## Quality Assurance of Chapter 11: Requirements on Upper Shelf Energy

This report documents the results of the quality assurance (QA) task for Chapter 11 of the draft technical basis NUREG for the risk-informed Appendix G project. Chapter 11 discusses the derivation of updated minimum upper shelf energy (USE) requirements for reactor vessels. The quality assurance effort for this chapter involved three specific subtasks: (1) confirming the validity of stress intensity factor equations used in Regulatory Guide (RG) 1.161, (2) verifying calculations of minimum USE based upon the RG 1.161 methodology, (2) verifying Fracture Analysis of Vessels-Oak Ridge (FAVOR) runs used to calculate minimum USE.

Figure 6: Required USE calculated according to RG 1.161 for (a) TB work and (b) QA work.

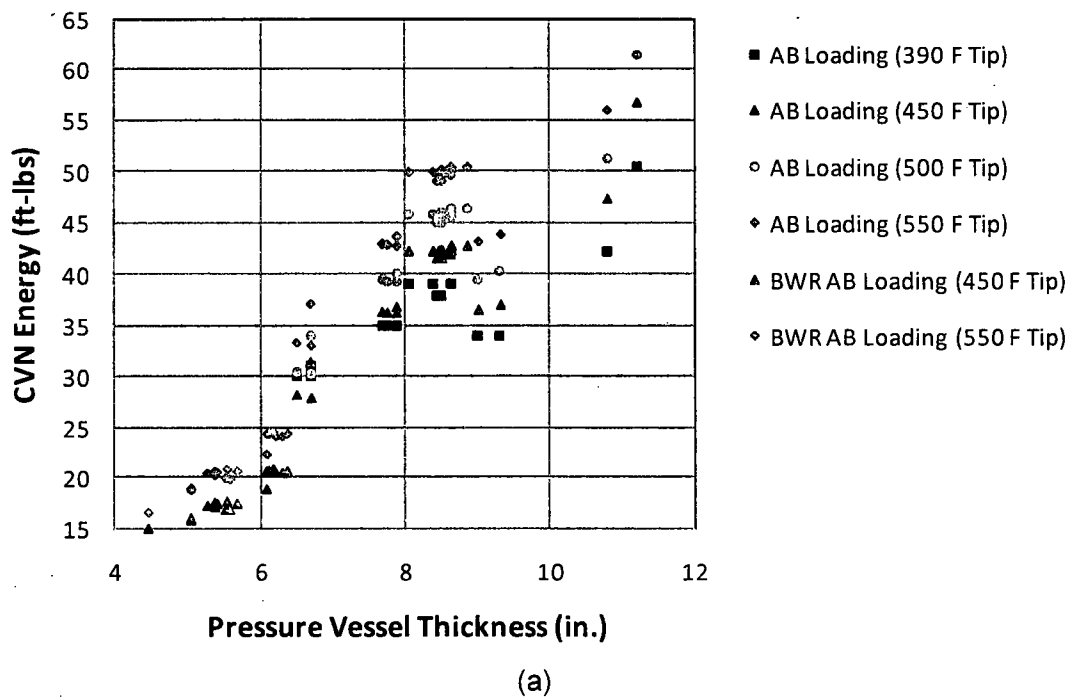
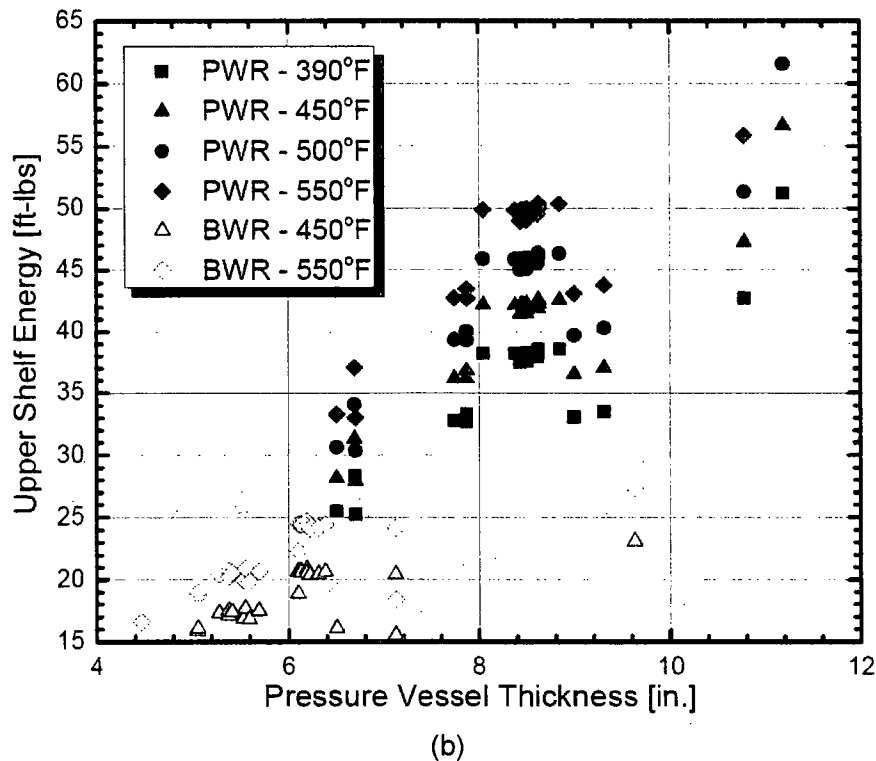
The interviews revealed one issue of concern for the RG 1.161 calculations: the crack stability criterion (Equation 2) was not employed in the TB work. As a matter of technical rigor, the crack stability criterion should always be included in the calculations, since the safety factor for that criterion is higher than that for the non-initiation criterion (Equation 1). The results of these calculations from the TB work and QA work are compared in Figure 6 (a) and (b), respectively.

The results from the QA work (which accounted for crack stability) compare well with the results from the TB work, demonstrating the fact that the non-initiation criterion plays a dominant role in determining required USE. The issue raised by the QA work, therefore, has little effect on the results of this calculation.

2. While the TB work incorrectly neglected the crack stability criterion for the RG 1.161 calculations, modifying the analysis to account for crack stability does not change the results of the analysis.

Figure 3: Comparison of required USE obtained from the RG 1.161 and FAVOR methods for (a) the TB work and (b) the QA work.

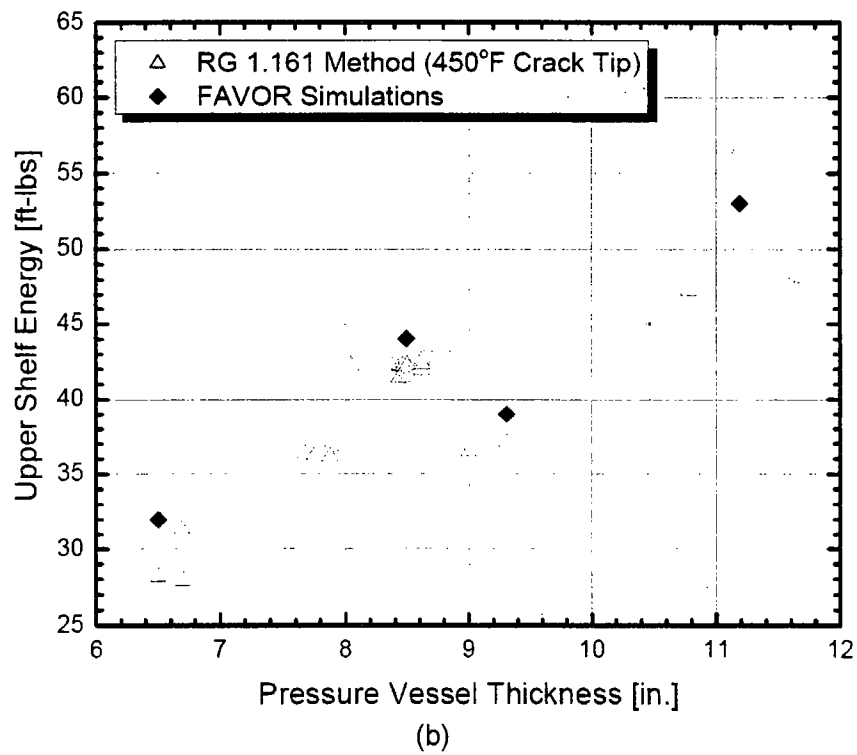
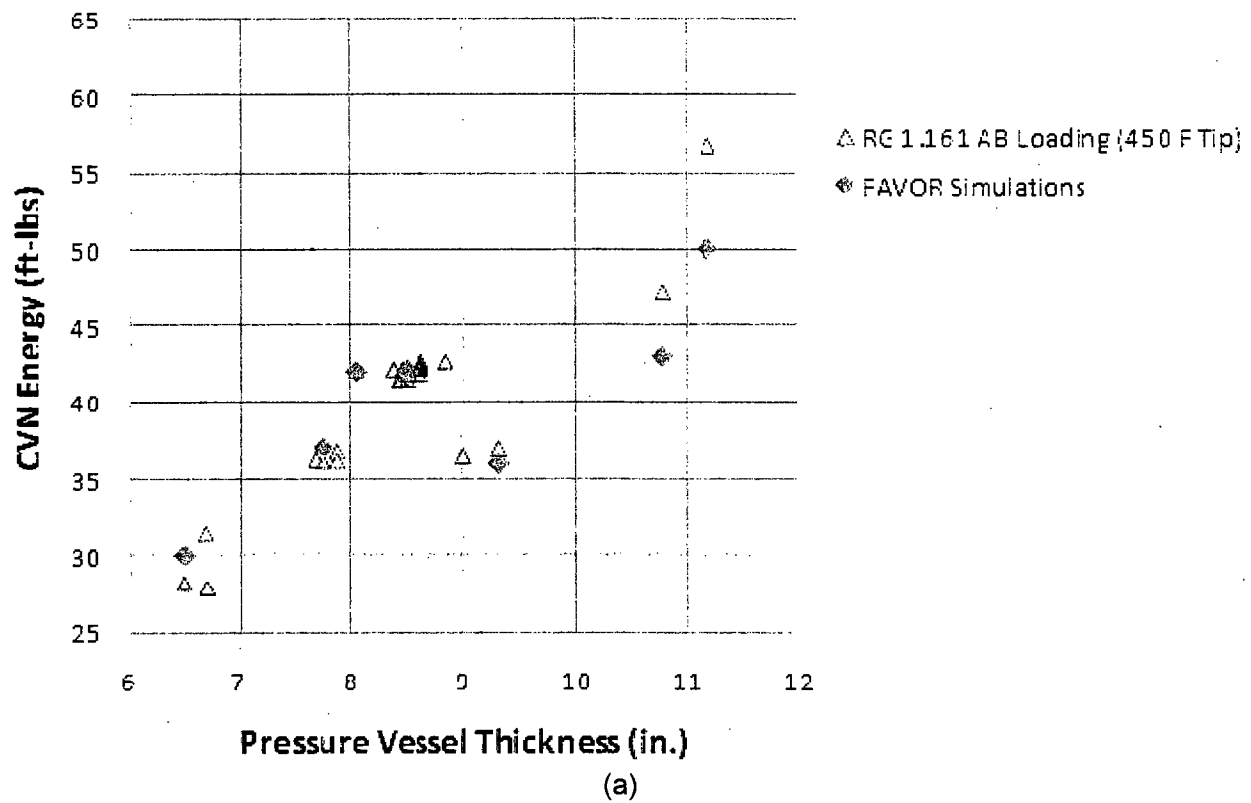
The QA calculations included a factor of 1.09 in the applied J calculation, in order to account for the small scale yielding correction. For the purposes of calculating required USE, this procedure is not recommended. For the purposes of the QA work, however, it provides a method to assess the error introduced by neglecting the small scale yielding correction. A comparison of Figures 3 (a) and (b) shows that the required USE is increased by roughly 3 ft-lbs when accounting for small scale yielding. The main conclusion of the TB regarding this work (i.e., that 450°F is the correct temperature input to  $J_R$  model) remains valid, since the results of the FAVOR simulations match closely with the results of the RG 1.161 calculation.

3. The proposed procedure to calculate J from FAVOR results neglects the small-scale yielding correction (Equation 7), which can increase the calculated J by 9%.

4. After adjusting the calculated J results by a factor of 1.09 to account for small scale yielding, the results still confirm the original conclusion from the draft TB: 450°F is an appropriate crack tip temperature to use for the RG 1.161 calculations.

Figure 5: Figure reference in draft TB to demonstrate a situation where the crack stability criterion is violated.

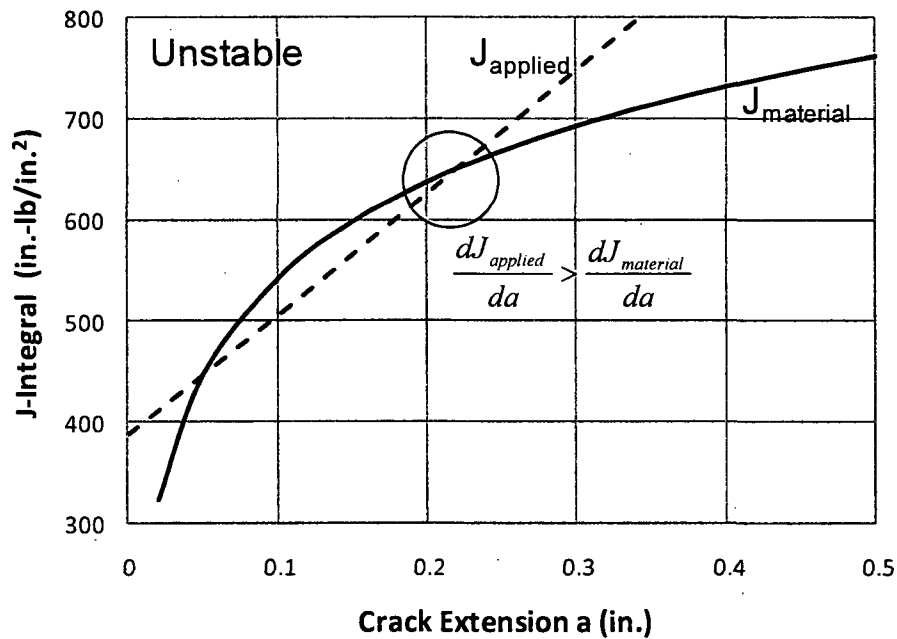
The draft TB for the minimum USE shows Figure 5 to demonstrate a situation where the crack stability criterion is not met.

In fact, Figure 5 illustrates a situation that meets the crack stability criterion, since there is a portion of the driving force curve (i.e., applied  $J$ ) that lies below the resistance curve (i.e.,  $J_{\text{material}}$  in the figure, or  $J_R$ ). While the slope of  $J$  is indeed greater than the slope of  $J_R$  at the point circled, the correct intersection point to perform this evaluation is the one located at lower crack extension. This concept can be confirmed by considering a figure from a fracture mechanics text (Figure 6).

5. Figure 5 should not be included in the TB to demonstrate instability, since it actually demonstrates stability.
6. The proposed thickness-dependent USE limit was independently verified by the QA work.

Figure 6: Demonstration of crack stability.

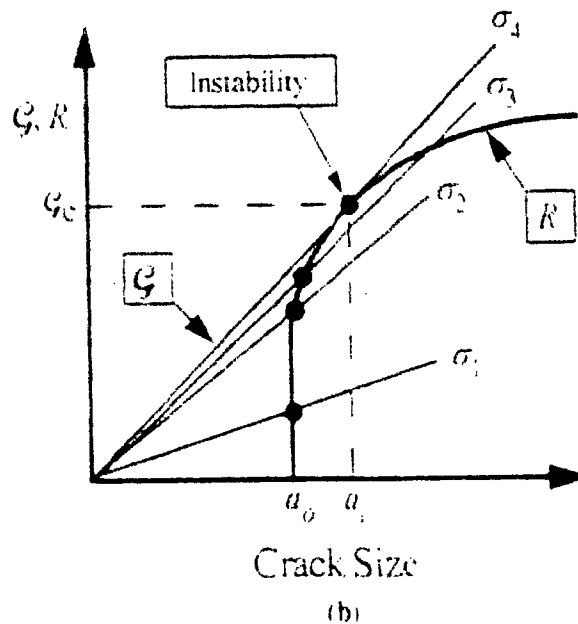
Figure 6 shows that instability begins when the driving force curve is tangent to the resistance curve. When the driving force curve is secant to the resistance curve, the crack is stable.
